**STATE OF CALIFORNIA
DEPARTMENT OF WATER RESOURCES**

**STATEMENT OF FINDINGS REGARDING THE
DISAPPROVAL OF
THE OJAI VALLEY ALTERNATIVE**

State of California
Department of Water Resources
Sustainable Groundwater Management Program
Alternative Assessment Staff Report

Groundwater Basin Name: Ojai Valley (Basin No. 4-002)
Submitting Agency: Ojai Basin Groundwater Management Agency
Recommendation: Do Not Approve
Date Issued: July 17, 2019

Figure 1. Ojai Groundwater Basin³⁸

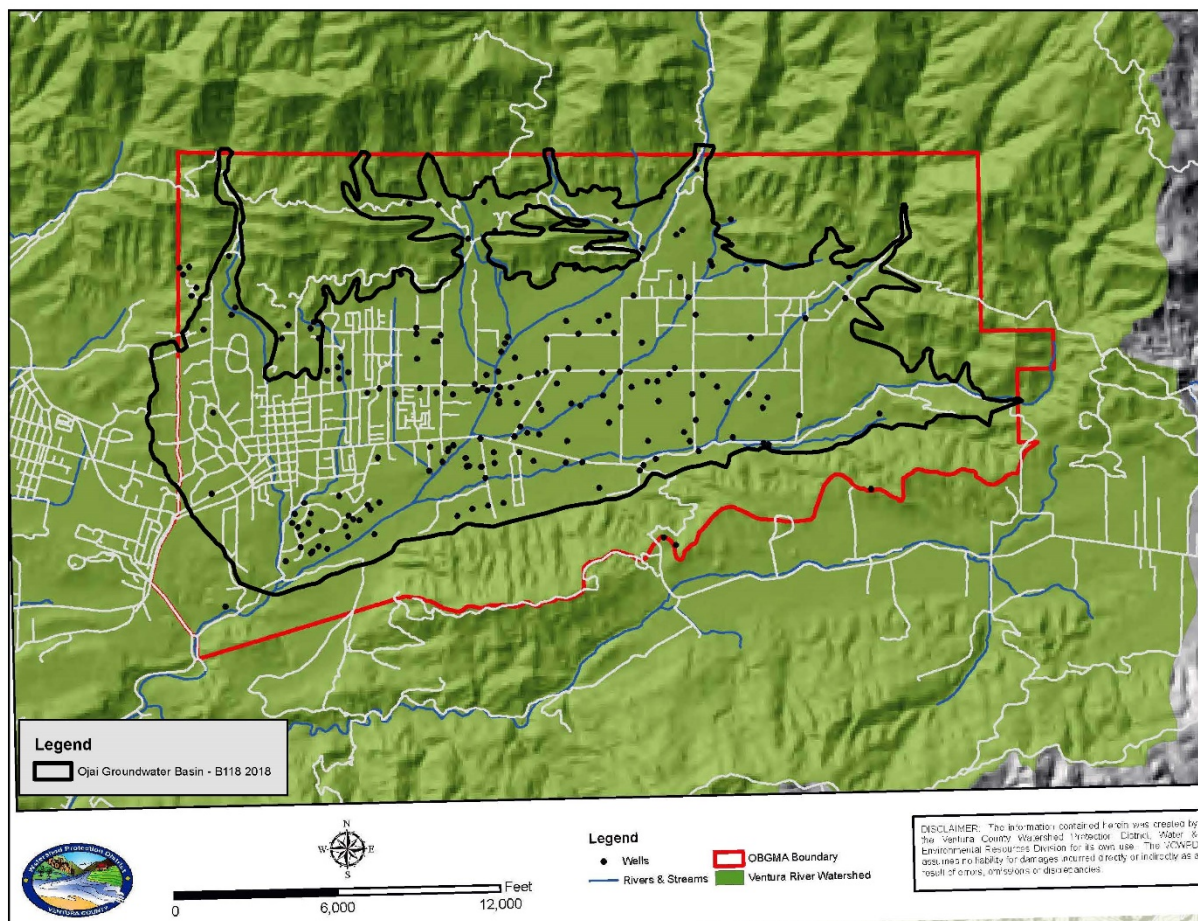
As shown in Figure 1, nearly the entire Ojai Basin (shown in black) is contained within the jurisdictional boundaries of the Ojai Basin Groundwater Management Agency (shown in red), which also includes area beyond the boundaries of the Basin.³⁷ However, small areas of the Basin extend beyond the Agency's jurisdictional boundary to the north and west.

To determine whether the alternative effectively covers the entire basin, the Department was required to determine whether groundwater management pursuant to the alternative has avoided undesirable results for at least 10 years. Because Department staff has determined that the analysis of basin conditions does not demonstrate that undesirable results have been absent for at least 10 years, the Department staff are unable to determine the Ojai Basin has reached sustainability. As a result, Department staff cannot conclude that the Alternative effectively covers the entire Basin. Although the failure to cover the entire basin precludes an alternative from approval, Department staff note that the failure to cover the entire basin is a consequence of the alternative not demonstrating sustainability in the area within the Agency’s jurisdiction. Department staff do not express
